# City of Sandy

**Planning Commission Meeting**  
**Meeting Location:** Hybrid - 39250 Pioneer Blvd. and Zoom  
**Meeting Date:** Monday, April 24, 2023  
**Meeting Time:** 6:30 PM

- 7.1. 22-031 DR/VAR/TREE State Street Homes Mixed-Use Development 12 - 302  
[22-031 DR/VAR/TREE State Street Homes Mixed-Use Development - Pdf](#)  
[Exhibit A Land Use Applications](#)  
[Exhibit B Narrative](#)  
[Exhibit C Plan Set](#)  
[Exhibit D and E Lighting Plans and Cut-Sheets](#)  
[Exhibit F Stormwater Report](#)  
[Exhibit G Transportation Analysis Letter](#)  
[Exhibit H Arborist Report](#)  
[Exhibit I ODOT Memo](#)  
[Exhibit J Indenture of Access](#)  
[Exhibit K and L Easements](#)  
[Exhibit M Parks Comments](#)  
[Exhibit N Fire Marshal Comments](#)  
[Exhibit O ODOT comments](#)  
[Exhibit P City Transportation Engineer DKS Comments](#)  
[Exhibit Q PW Comments](#)  
[Exhibit R Third Party Arborist Review](#)  
[Exhibit S ODOT Comments State Street Homes pre-app](#)  
[Exhibit T Email from ODOT](#)  
[Exhibit U Sandy Multi-Family Site Plan Revisions \(rcvd Feb 9, 2023\)](#)  
[Exhibit V Dennis Petross Public Comments \(received February 14 2023\)](#)

**L2.1**

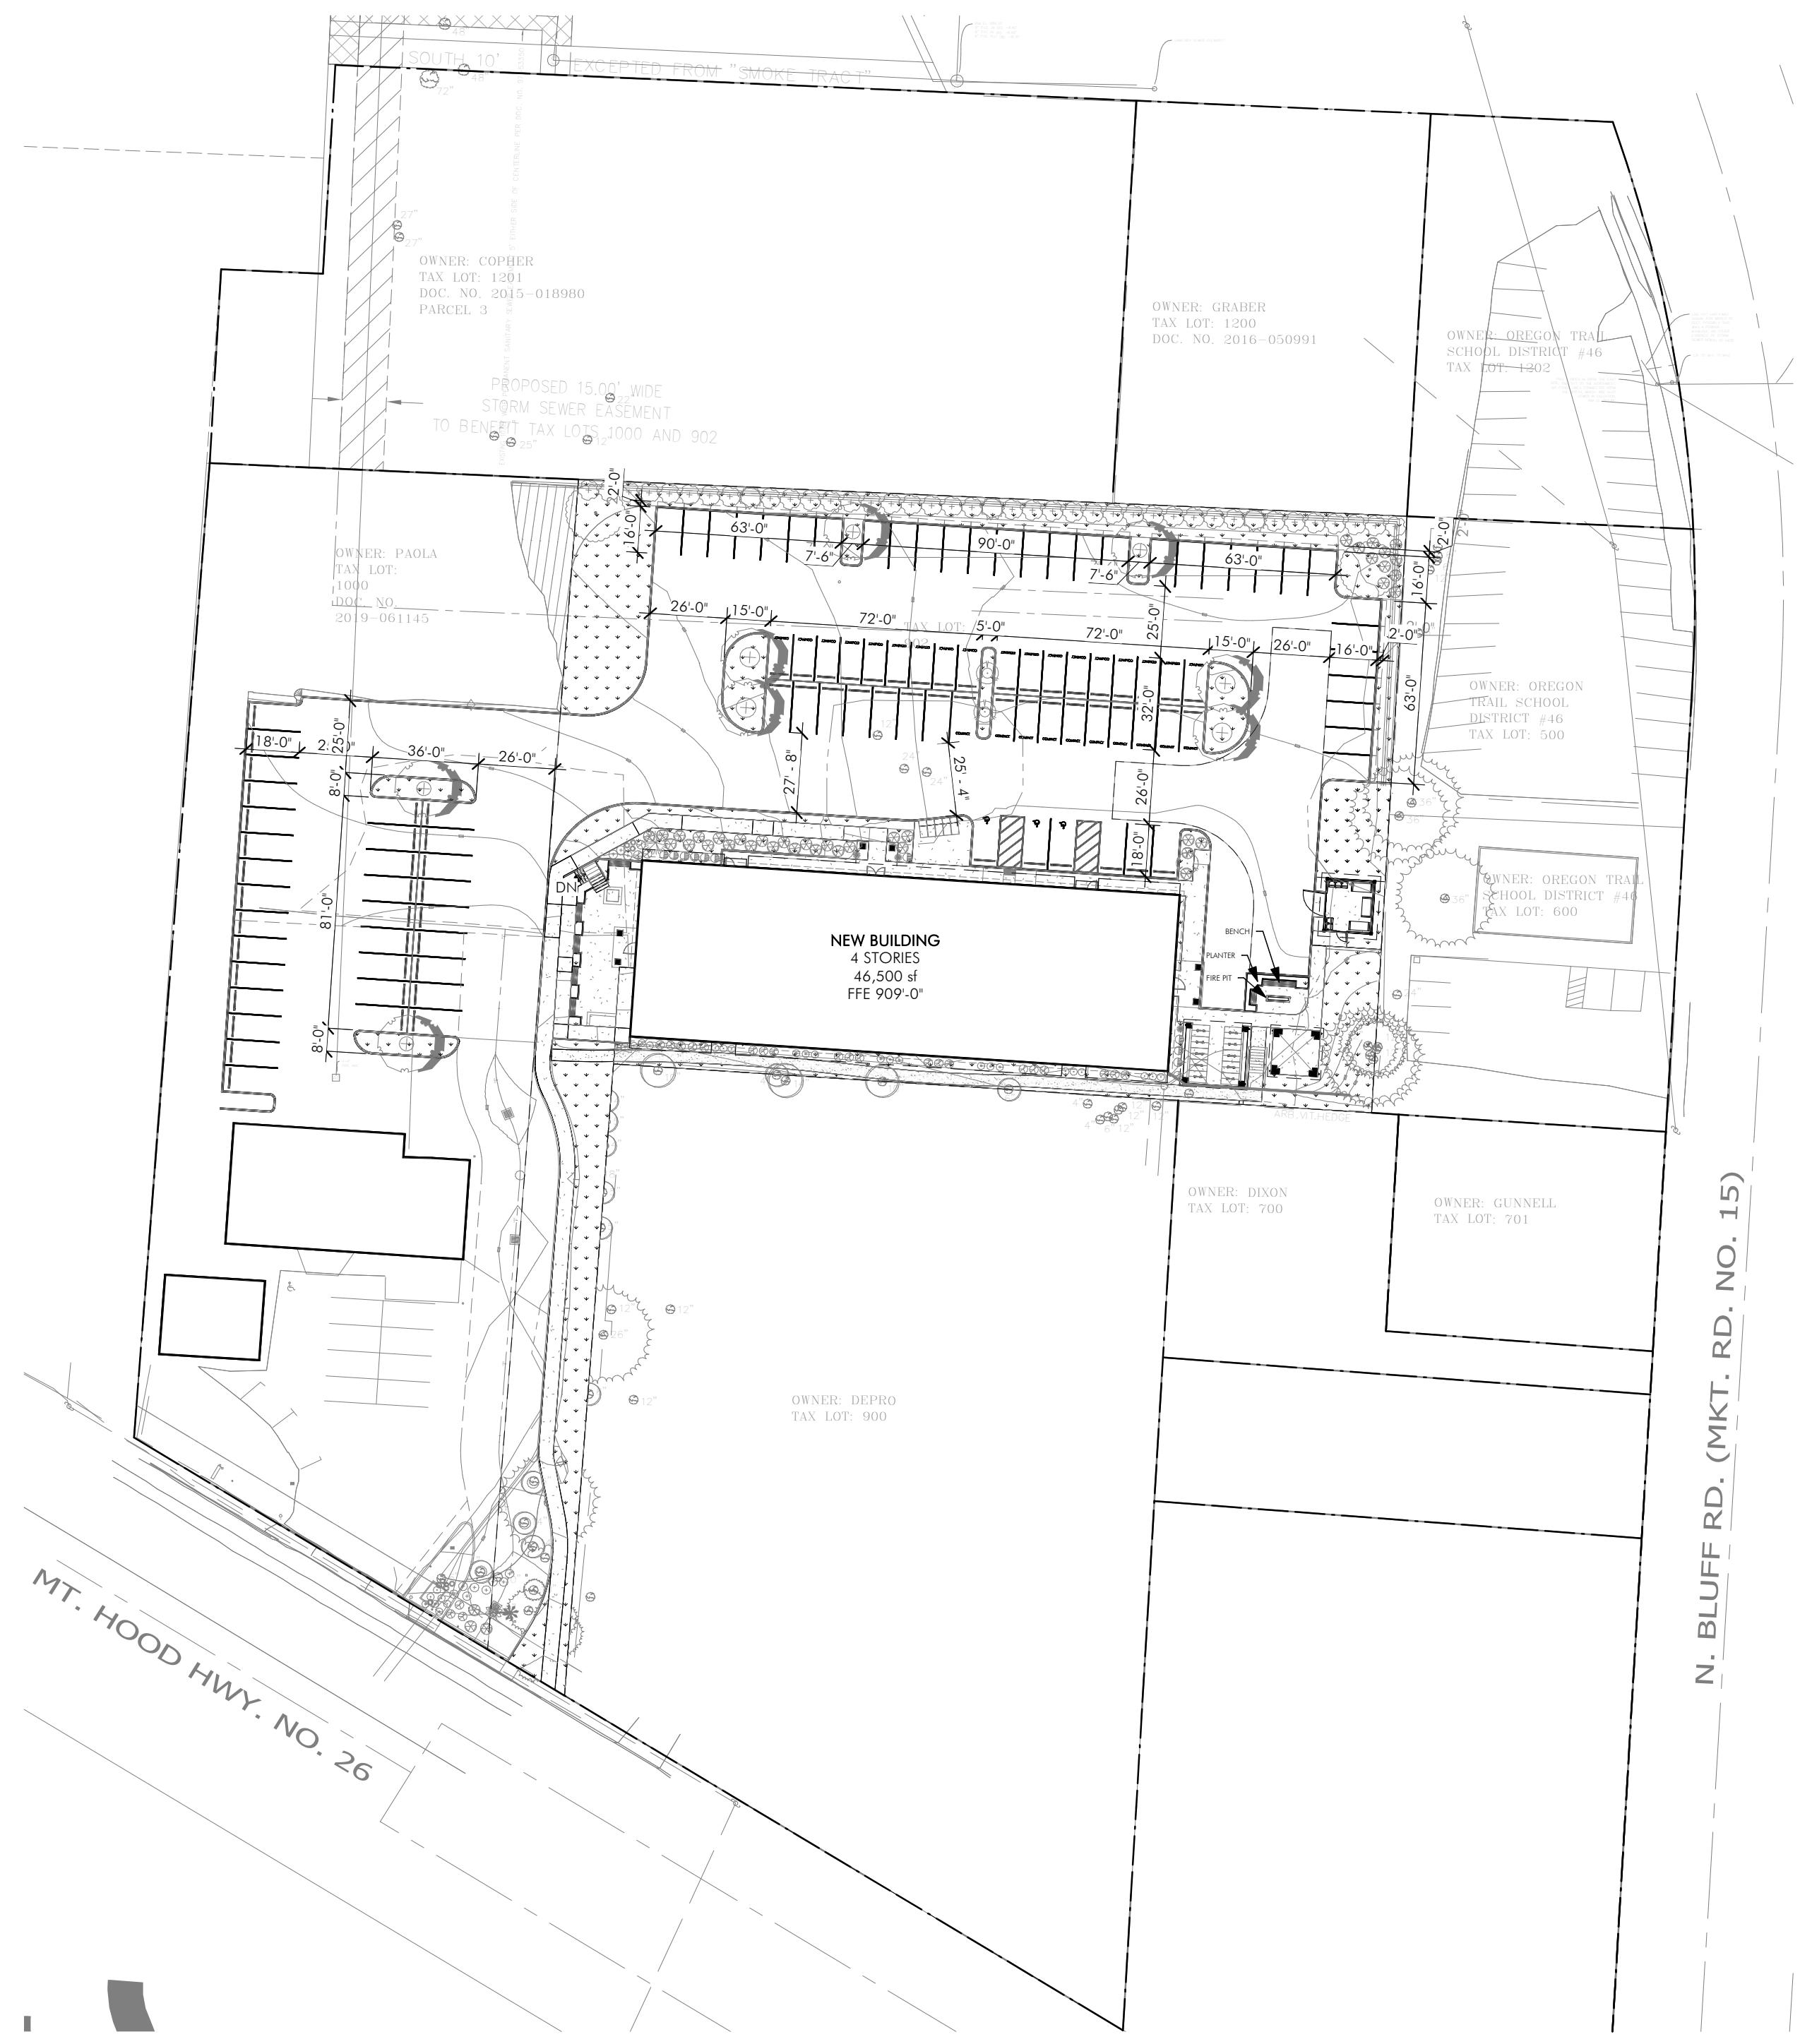
~~121.~~132. Section 17.92.40 requires that all landscaping shall be irrigated, either with a manual or automatic system. The Preliminary Planting Plan (Exhibit C, Sheet L2.1) states that the irrigation system will be an "automated underground system design build by the landscape contractor." **The applicant shall submit details on the proposed automatic irrigation system with building plans. Per Section 17.92.10(L), all landscaping shall be continually maintained, including necessary watering, weeding, pruning and replacing.**

~~123.~~134. Section 17.92.50(B) encourages the use of native plant materials or plants acclimatized to the Pacific Northwest where possible. The Preliminary Planting Plan (Exhibit C, Sheet L2.1) includes two native plants. The remaining proposed plants are not native to the Pacific Northwest but are also not nuisance species. **Staff recommends the applicant update the Preliminary Planting Plan to detail native species or water-efficient plants acclimated to the Willamette Valley. If the Planning Commission approves the applicant's request for a variance to the minimum tree retention standards, staff recommends the Planning Commission require the applicant to update the Planting Plan to detail all new landscaping as native species or water-efficient species acclimated to the Willamette Valley,** consistent with the conservation benchmarks in the City of Sandy 2016 Water Management and Conservation Plan.

5. Submit an updated Preliminary Planting Plan to detail the following:
  - a. A minimum 5-foot-wide (interior dimension) landscape planter with a mix of low-lying ground cover and shrubs, and vertical shrubs and trees between the proposed westernmost parking row on Tax Lot 1000 and the property to the west. The revised plan (Exhibit Y, Sheet L2.1) details this landscape planter at only 2 feet in width.

**NEW MULTI-FAMILY DEVELOPMENT**  
 SANDY  
 38015 HWY 26  
 OR  
 SITE LIGHTING PLAN

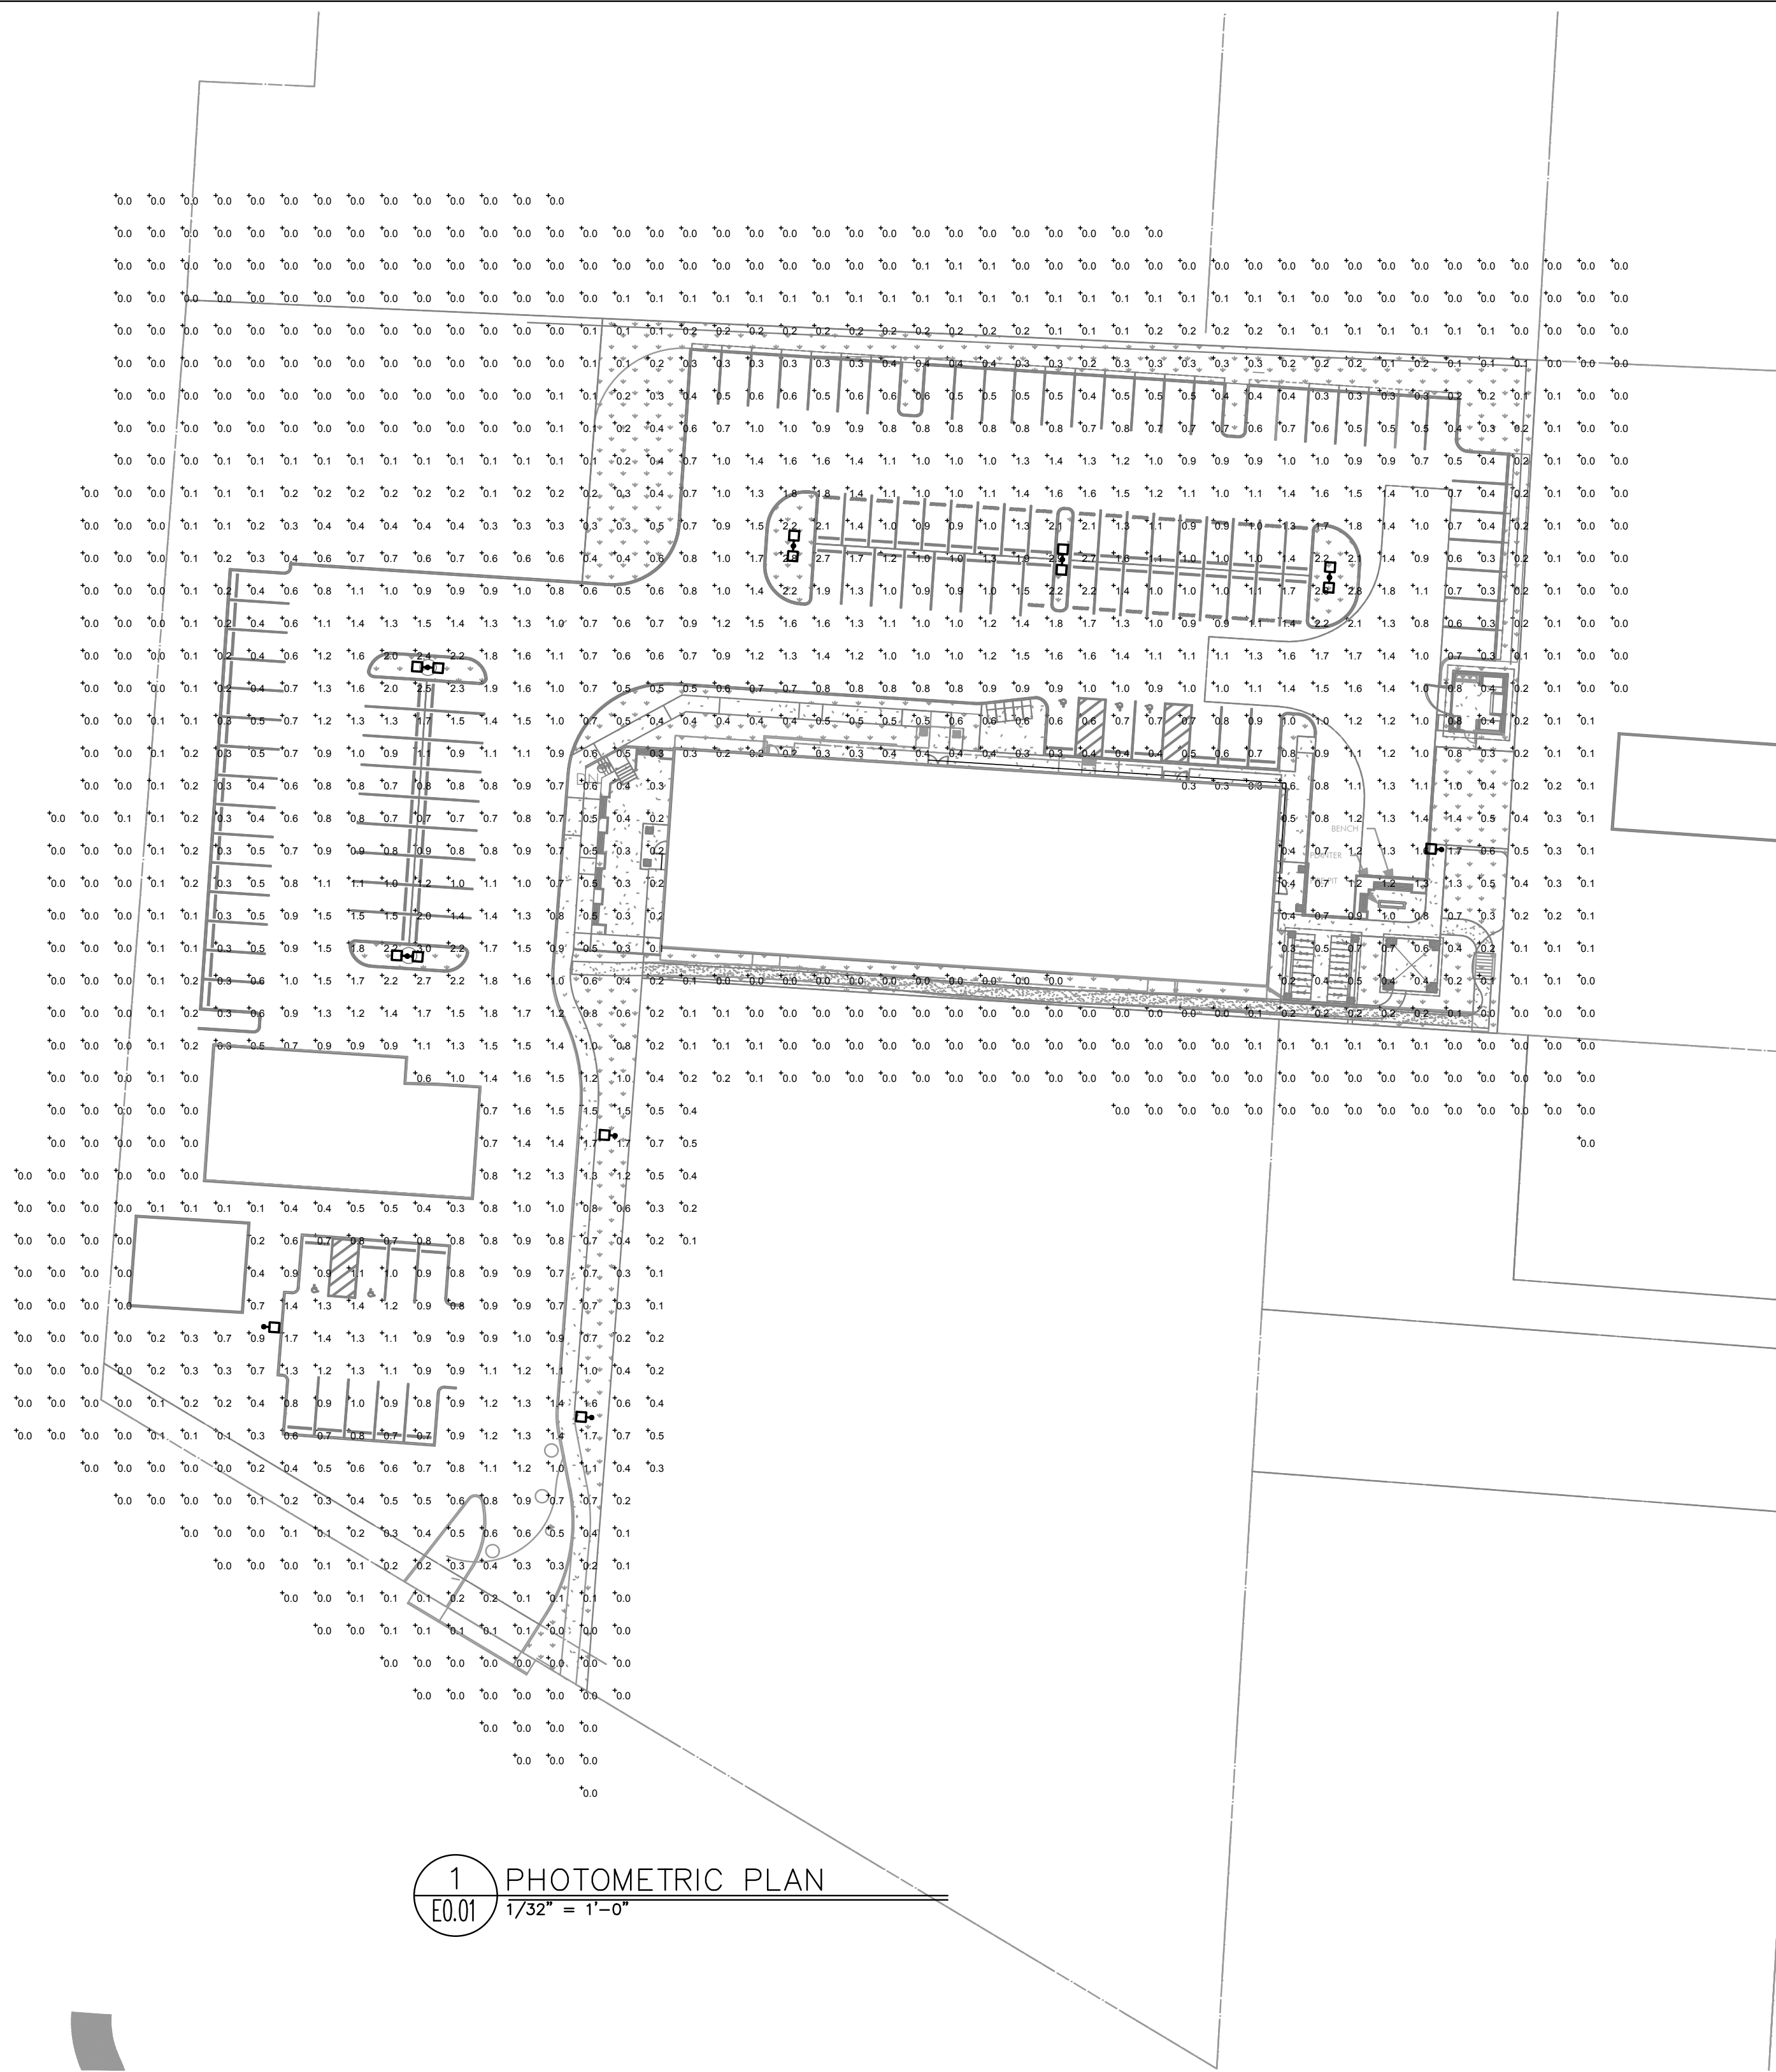
~~100.~~110. Chapter 15.30 contains the City of Sandy's Dark Sky Ordinance. The applicant submitted a Site Lighting Plan (Exhibit D, Sheet E0.00), Photometric Plan (Exhibit D, Sheet E0.01), and a lighting fixture cut sheet (Exhibit E) for a D-Series Size 0 LED Area Luminaire by Lithonia Lighting. The Site Lighting Plan details four (4) single-headed lights and five (5) double-headed lights and specifies that the lights will be 3,000 Kelvins in compliance with the code. **Downward facing, full cut-off lighting shall be required. Lights shall not exceed 4,125 Kelvins or 591 nanometers to minimize negative impacts on wildlife and human health.**

~~101.~~111. Section 15.30.060(D) states that all outdoor lighting systems shall be designed and operated so that the area ten feet beyond the property line of the premises receives no more than one-quarter of a foot-candle of light from the premises lighting system. The submitted Photometric Plan (Exhibit D, Sheet E0.01) details foot candles extending 10 feet beyond the property lines. Light trespass onto adjacent properties is detailed to exceed the 0.25 foot-candle maximum on the property east of the flagpole (Tax Lot 900) as well as the property east of the flag portion of Tax Lot 902 (Tax Lot 600). In addition, the applicant is required to provide lighting along the proposed path south of the mixed-use building, which will need to be analyzed for light trespass. **The applicant shall update the Photometric Plan such that the area ten feet beyond the property line of the subject properties receives no more than one-quarter of a foot-candle of light from the development's lighting system.**
